**RE: Reclamation District No. 341 (Sherman Island)  
Project Funding Agreement SH-18-1.1-SP**

Enclosed for you review and approval, is the revised Five-Year Plan submitted on the behalf of Reclamation District No. 341 (District). For your convenience, the comments in your letter dated February 23, 2021, are provided below in italics followed by the District's response:

**RECLAMATION DISTRICT NO. 341**  
**SHERMAN ISLAND**  
**FIVE-YEAR PLAN**

**Figure 2. Location Map**

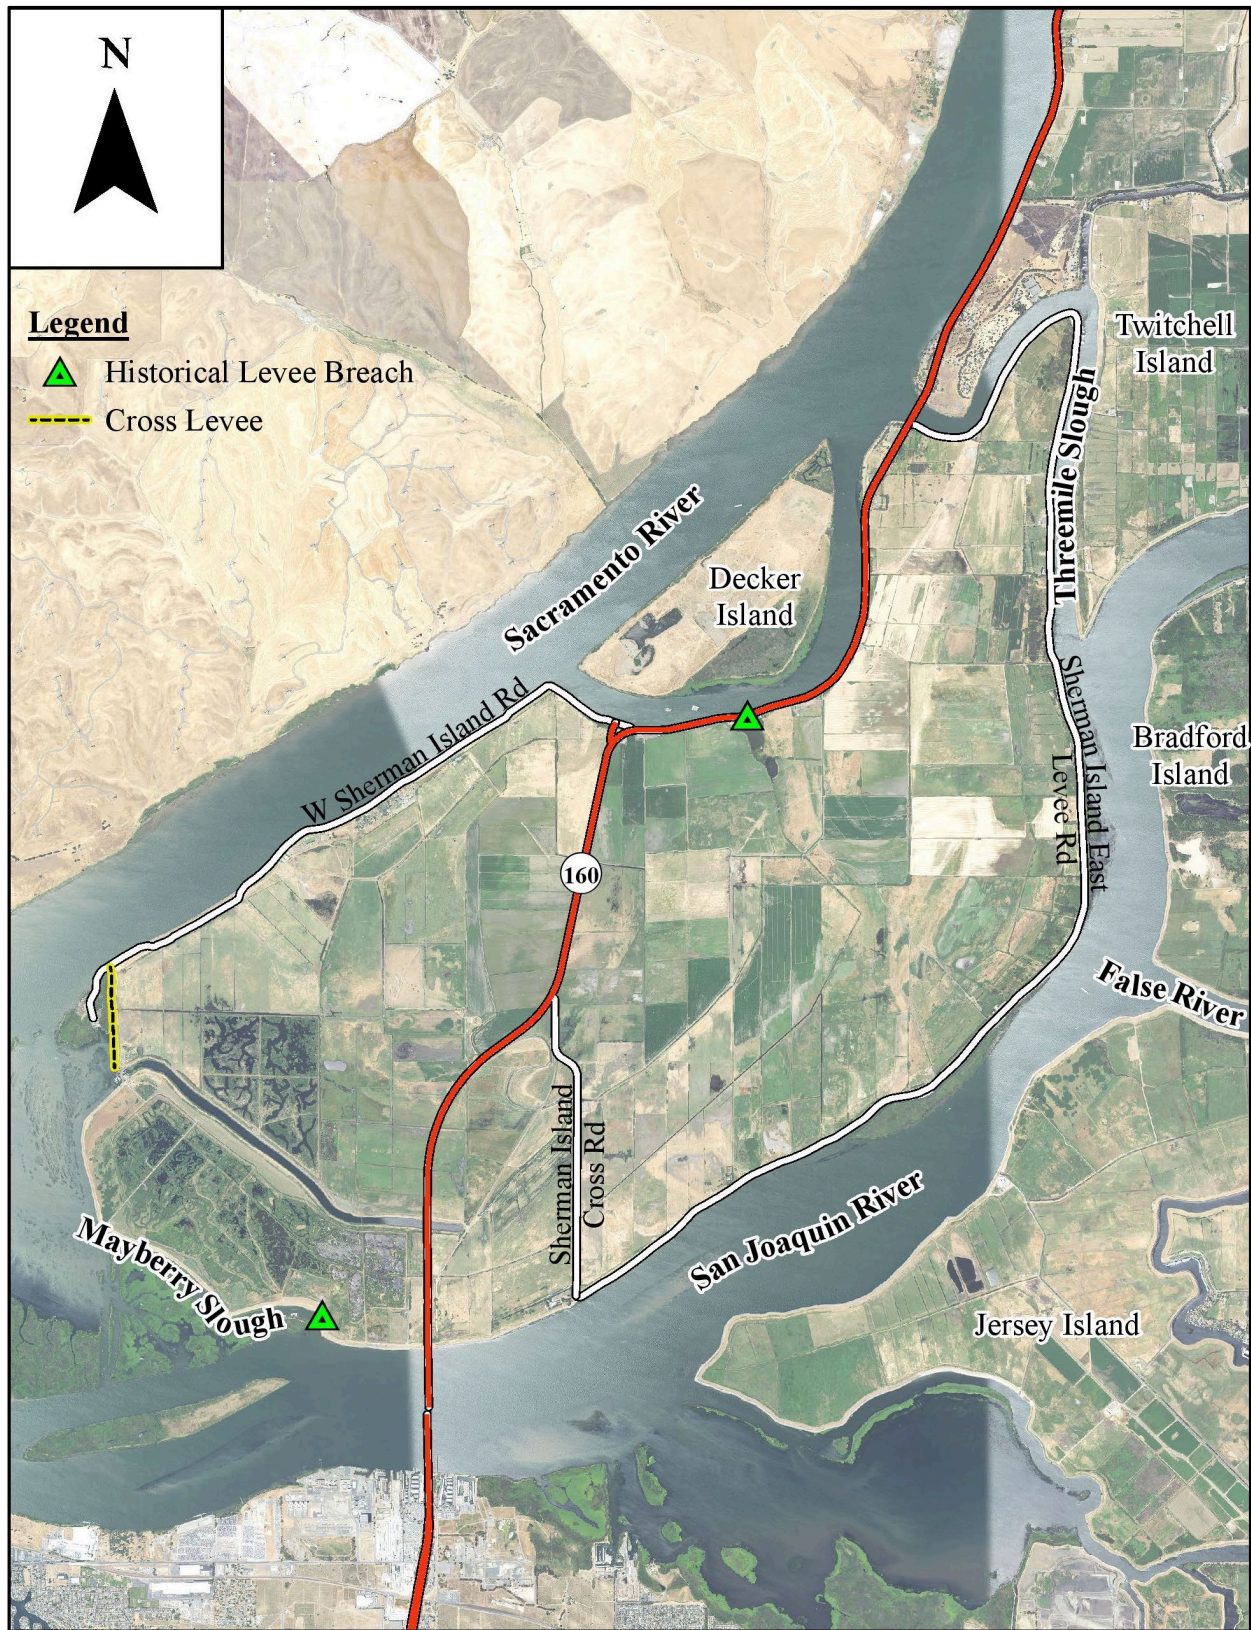
- *If possible, please provide a figure showing some of the significant features detailed in the historical flooding account. For example, identify the 3,000-foot Cross Levee between Sacramento River and Mayberry Slough, and sites of significant levee breaches.*

Figure 2 (Location Map) has been revised to include the Cross Levee and sites of significant levee breaches.
